BR167 ARTICO Seat Covers On Front Seat Torn

Topic number LI91.18-P-071629

Function group 91.18 - Seat covers

Example 3

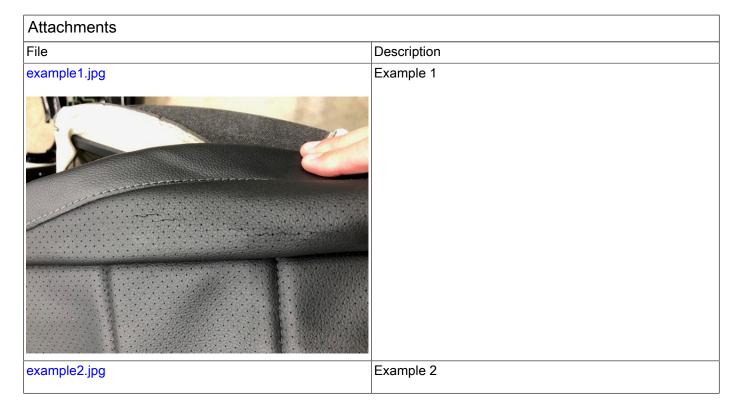
On vehicles with "ARTICO man-made leather upholstery" or "ARTICO man-made leather upholstery / DINAMICA microfiber - black (601A)" the material of the seat side bolster can tear. Both the seat cushion cover and the backrest cover on the front seat can be affected here.

The material may tear because the material in the side bolster is not suitable.

Optimized seat covers are available in XPPI (Xentry Portal Parts Information).

The new seat covers have the addition "PREMIUM" in the description. Please take note of this! In the event of questions or problems concerning the seat covers, please open a PTSS case.
